QUALITY ASSURANCE -- NON-CONFORMANCE REPORT

Report No: NCR-000674

Welding	Concrete	Other	
Welding	Curing	Procedural	Bridge No: 34-0006
Joint fit-up	Coating	Other	Component: Suspender Bracket for Lift 6 West
Procedural	Procedural	Description:

Reference Description: New welds built up were performed by ZPMC in 2 Suspender Brackets for Lift 6 West. The operation was done without Engineer's Approval

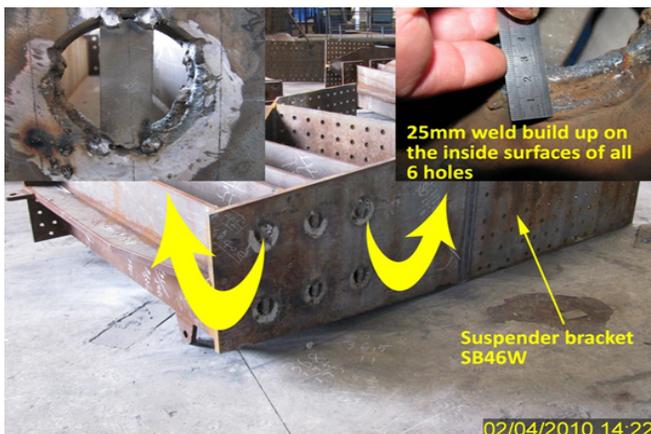
ZPMC personnel have performed weld built up the inside surfaces of suspender rod holes with weld metal without the approval of the Engineer. ZPMC introduced new welds that were not specified in the approved shop drawings.

-The suspender brackets are designated as Tension Member/Stress Reversal Members (TM/SRM) in the contract documents.

-The suspender brackets affected are identified on the material as SB42W (for Segment 6BW) and SB46W (for Segment 6CW).

-This condition exists on all six (6) rod holes on both of the above mentioned brackets.

AWS D1.5 2002 section 3.7.4 specifies "Prior approval of the Engineer shall be obtained for repairs to base metal (other than those required by 3.2), repair of major or delayed cracks, repairs to ESW and EGW welds with internal defects, or for a revised design to compensate for deficiencies."

AWS D1.5 2002 section 3.7.7.2 specifies "Base metal subject to dynamic tensile stress may be restored by welding providing the following apply:

(1) The Engineer approves both repair by welding and the repair WPS"

ZPMC acknowledges that a CWR should have been issued in this case. ZPMC is providing the WRR that was sued at the time as well as the NDT after to show that the base metal repair was successful. In the future, ZPMC acknowledges that greater attention must be paid to avoid these types of NCRs. Based on this, ZPMC requests closure of this NCR.

This proposed resolution is acceptable. The documentation received is sufficient and the Department concurs that Non-Conformance ZPMC-0642 is closed.

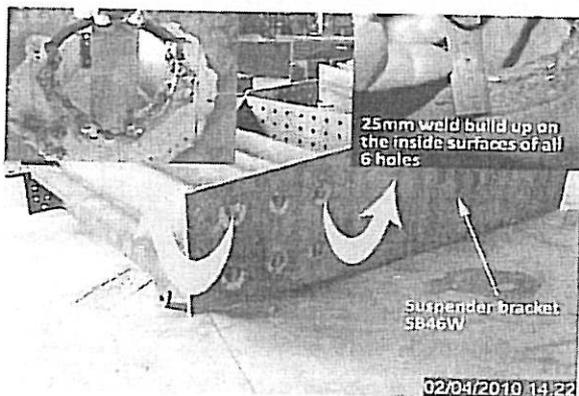
ZPMC personnel have performed weld built up the inside surfaces of suspender rod holes with weld metal without the approval of the Engineer. ZPMC introduced new welds that were not specified in the approved shop drawings.

-The suspender brackets are designated as Tension Member/Stress Reversal Members (TM/SRM) in the contract documents.

-The suspender brackets affected are identified on the material as SB42W (for Segment 6BW) and SB46W (for Segment 6CW).

-This condition exists on all six (6) rod holes on both of the above mentioned brackets.

Perform NDT required to verify weld quality.

Contractor submitted WRR used during welding along with subsequent NDT reports verifying repair quality complies with Contract specifications.

项目名称 Project Name	美国海湾大桥 SFOBB	部件图号 Drawing No	SB42W	报告编号 Report No.	B-WR10612
合同号 Contract No.:	04-0120F4	部件名称 Items Name	悬索支架 Suspending Bracke t	NDT报告编号 Report No.of NDT	NA
项目编号 Project No.:	ZP06-787

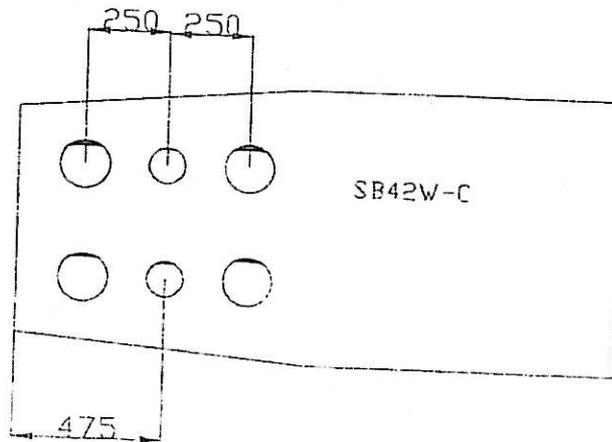
根据检查报告 ZP06-787-J-B-1361 工艺处理意见, 悬索支架 SB42W-C 如图阴影部分所示的孔的位置需堆焊 15mm.

Suspending bracket (SB42W-C) was needed to build-up 15mm according to inspection report (ZP06-787-J-B-1361).

焊接变形和制作误差。

Weld distortion and fabricate error.

1. 将孔采用碳刨的方法拓宽，并打磨平滑，拓宽的孔应符合修补WPS中的接头细节。碳刨前应根据相应的WPS进行预热；
 2. 焊接前采用VT检测确保无缺陷存在；
 3. 贴加钢衬垫，根据返修WPS进行预热及焊接，焊接时采用线状纵向进行补焊；
 4. 去除衬垫，根部焊道反面碳刨清根焊接；
 5. 焊后将焊缝打磨与周围母材齐平；

6. 采用进行VT、UT、MT对返修区域进行检测；
 7. 按照图纸及检查报告ZP06-787-J-B-1361处理意见重新钻孔；
1. Elongate the hole by arc gouging, and grind smooth the surface. The elongated hole should conform to the joint detail in Repair WPS. Preheat before gouging according to relevant WPS.

2. Perform VT to ensure no defects exist.
 3. Add steel backing. Preheat and weld according to the repair WPS, weld stringers longitudinally along the elongated direction of the hole.

4. Remove steel backing and back gouge the root pass, and complete the welding.
 5. Grind the repair area flush with adjacent base metal.
 6. Check with VT, UT, MT after welding to the repair area.

7. Drill new holes according to work drawings and disposition of Inspection Report ZP06-787-J-B-1361.

项目名称 Project Name	美国海湾大桥 SFOBB	部件图号 Drawing No	SB46W	报告编号 Report No.	B-WR10613
合同号 Contract No.:	04-0120F4	部件名称 Items Name	悬索支架 Suspending bracke t	NDT报告编号 Report No.of NDT	NA
项目编号 Project No.:	ZP06-787

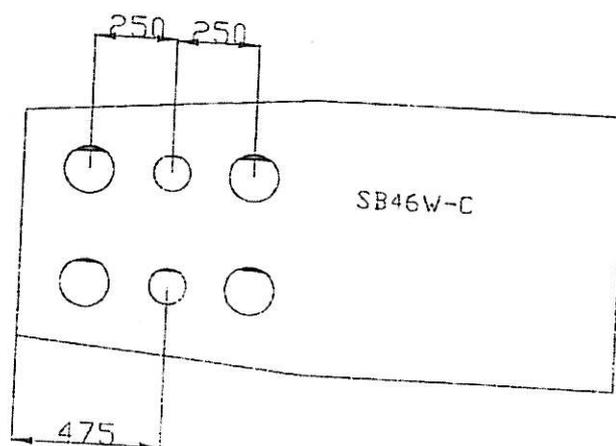
根据检查报告 ZP06-787-J-B-1361 工艺处理意见, 悬索支架 SB46W-C 如图阴影部分所示的孔的位置堆焊 15mm.

Suspending bracket (SB46W-C) was needed to build-up 15mm according to inspection report (ZP06-787-J-B-1361).

焊接变形和制作误差。

Weld distortion and fabricate error.

1. 将孔采用碳刨的方法拓宽，并打磨平滑，拓宽的孔应符合修补WPS中的接头细节。碳刨前应根据相应的WPS进行预热；
 2. 焊接前采用VT检测确保无缺陷存在；
 3. 贴加钢衬垫，根据返修WPS进行预热及焊接，焊接时采用线状纵向进行补焊；
 4. 去除衬垫，根部焊道反面碳刨清根焊接；
 5. 焊后将焊缝打磨与周围母材齐平；
 6. 采用进行VT、UT、MT对返修区域进行检测；
 7. 按照图纸及检查报告ZP06-787-J-B-1361重新钻孔；
1. Elongate the hole by arc gouging, and grind smooth the surface. The elongated hole should conform to the joint detail in Repair WPS. Preheat before gouging according to relevant WPS.
 2. Perform VT to ensure no defects exist.
 3. Add steel backing. Preheat and weld according to the repair WPS, weld stringers longitudinally along the elongated direction of the hole.
 4. Remove steel backing and back gouge the root pass, and complete the welding.
 5. Grind the repair area flush with adjacent base metal.
 6. Check with VT, UT, MT after welding to the repair area.
 7. Drill new holes according to work drawings and disposition of Inspection Report ZP06-787-J-B-1361.
